Prairie Island Nuclear Generating Plant, Units 1 and 2
Docket Nos. 50-282 and 50-306
Renewed Facility Operating License Nos. DPR-42 and DPR-60

Response to Request for Additional Information Regarding License Amendment Request to Revise Technical Specification 3.8.7 to Remove Non-Conservative Required Action (CAC Nos. MF8319 and MF8320)

LICENSE AMENDMENT REQUEST TO REVISE TECHNICAL SPECIFICATION 3.8.7 TO REMOVE NON-CONSERVATIVE REQUIRED ACTION

Figure 1, Schematic of Safety-Related PINGP Inverter

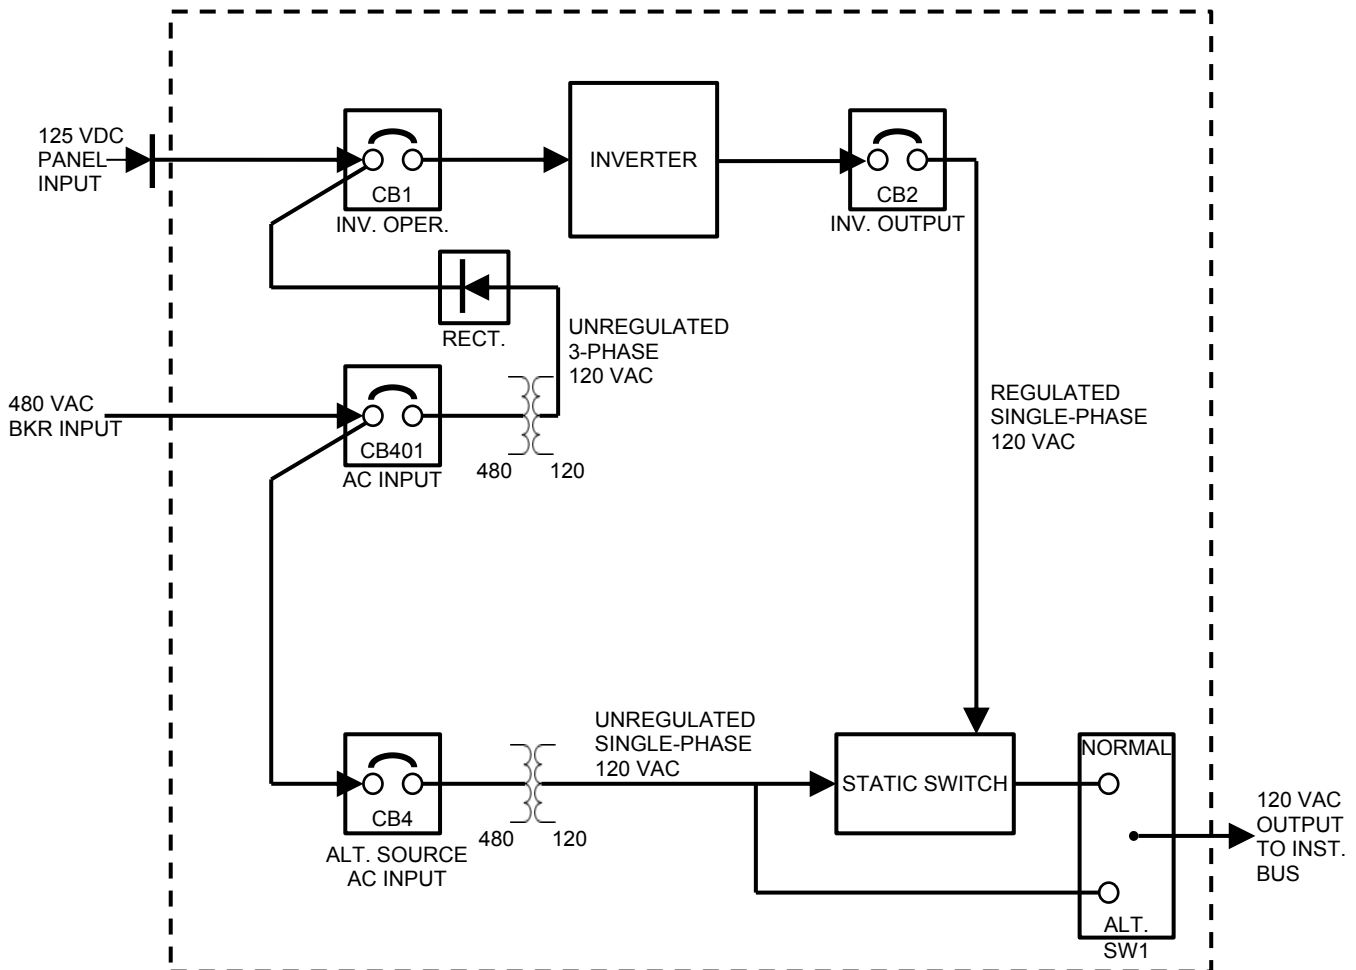
Provide the technical basis including a summary of the failure modes and effects evaluations for having non-safety-related Panels 117 and 217 as back-up power supplies for the safety-related Reactor Protection Instrument AC Panels as opposed to safety-related back-up power sources as stated in NUREG-1431 STS Bases for TS 3.8.7 Required Action A.1.

The PINGP Reactor Protection Instrument AC inverters include an internal inverter bypass source, which is the safety-related backup source identified in Reference 2. Non safety-related Panels 117 and 217 are not the back-up power supplies for the safety-related Reactor Protection Instrument AC panels. For clarity, the Reactor Protection Instrument AC panels will be referred to as the "instrument buses" hereafter in NSPM's response. The manually operated supply breakers which feed the instrument buses from Panels 117 and 217 are kept open during normal operations and are interlocked with the supply breakers from the inverters so only one breaker can be closed at a time. The breakers' positions are verified weekly in accordance with TS Surveillance Requirements (SRs) 3.8.7.1 and SR 3.8.9.1 to ensure the inverters are always aligned to the instrument buses. Figure 1 below depicts the configuration of a typical PINGP inverter.

The primary flow path of power through the inverter during normal operations is shown through the upper branch in Figure 1. Power is transmitted from the upstream safeguards 480 V MCC to the inverter. The power is stepped down to 120 VAC and then rectified to Direct Current (DC) power. The rectified DC power is then compared to the 125 VDC battery power by means of blocking diodes. The higher voltage power supply is passed to the inverter. The DC power is then inverted to AC power and fed to the static switch.

The safety-related inverter bypass source is illustrated by the lower branch in Figure 1. An additional tap off of the safeguards 480 V MCC is stepped down to 120 VAC via a separate power transformer. The output from this transformer is then fed to the static switch. The normal

output from the static switch is from the battery-backed inverter (i.e., the upper flow path). The safety-related backup output is from the alternate source transformer (i.e., the lower flow path). The static switch provides a virtually instantaneous transfer of power in the event that the preferred flow path becomes unavailable.

Figure 2, Unit 1 Containment Spray Automatic Initiation Logic

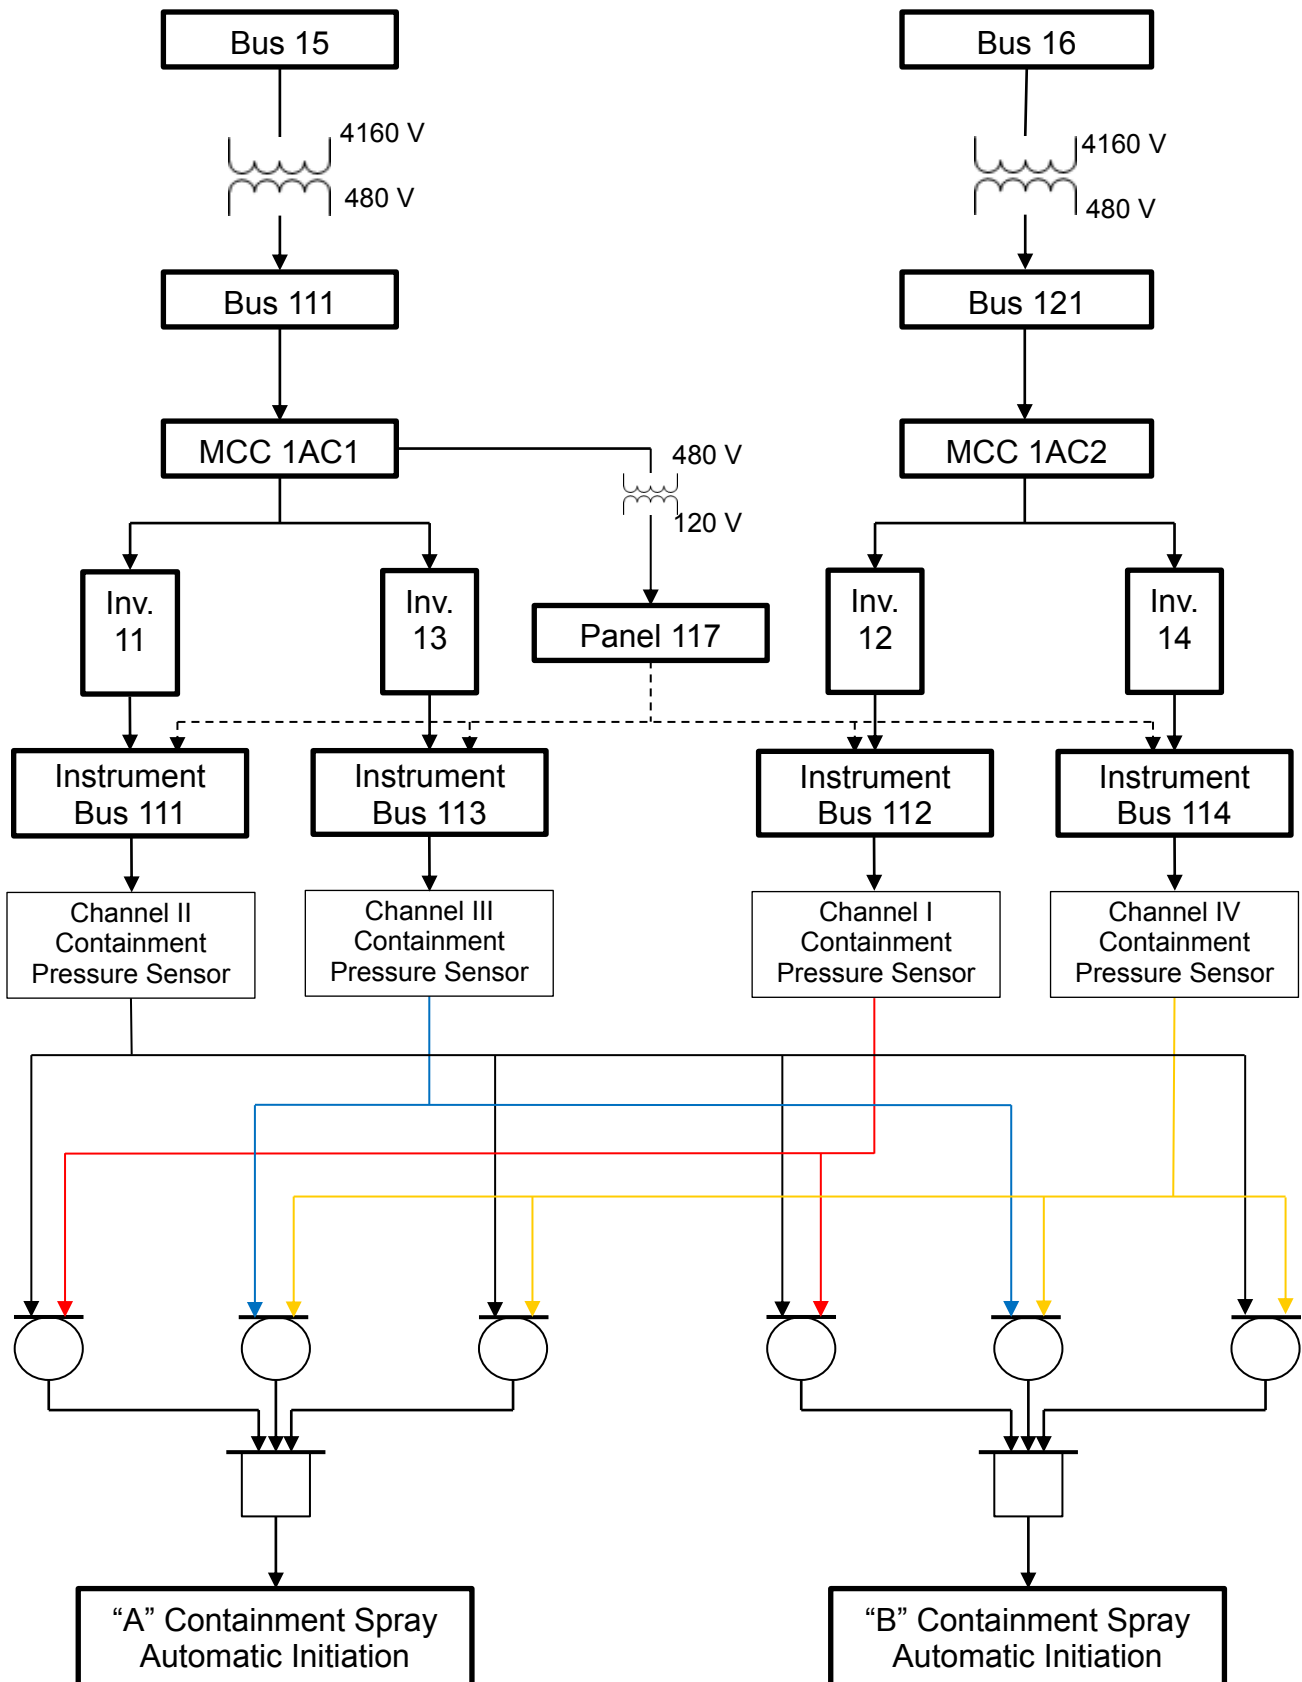
Provide a diagram which would provide a depiction of the following statement: “for a worst-case single failure with Panel 117 (217) aligned to a Reactor Protection Instrument AC Panel, the required number of instrument buses to initiate an automatic Containment Spray system start would not be energized thus defeating the automatic start function.” For the case when one Train B Reactor Protection Instrument AC Inverter is inoperable, describe how independence/redundancy is maintained between Train A and Train B inverters and safety-related equipment while the affected Train B Reactor Protection Instrument AC panel is being powered by Train A Panel 117 (or Panel 217).

The requested diagram is included as Figure 2. The containment spray system automatic start logic at PINGP is one out of two taken three times and is “energize to actuate”. This differs from the other engineered safeguard features installed in the plant in that on a loss of power to the instrument buses, a start signal will not be propagated to the containment spray system. In the event that Panel 117 is providing power to Instrument Bus 112, the logic for Channels I, II, and III are all ultimately powered from MCC 1AC1. If a loss of MCC 1AC1 were to occur, only the Channel IV initiation logic would remain energized. Channel IV does not provide an input to three logic gates in either train of the containment spray actuation logic. Therefore, there are not enough energized Reactor Protection Instrument AC Panels to initiate an automatic containment spray system actuation.

For the case where one Train B instrument bus is being powered from Panel 117 (217) instead of its associated inverter, independence/redundancy is not preserved. This alignment and resulting lack of independence/redundancy would result in, as proposed in Reference 1, NSPM declaring LCO 3.8.7 not met and taking the necessary actions to restore the inverter to operable status within 24 hours or shut the plant down in the following 36 hours.
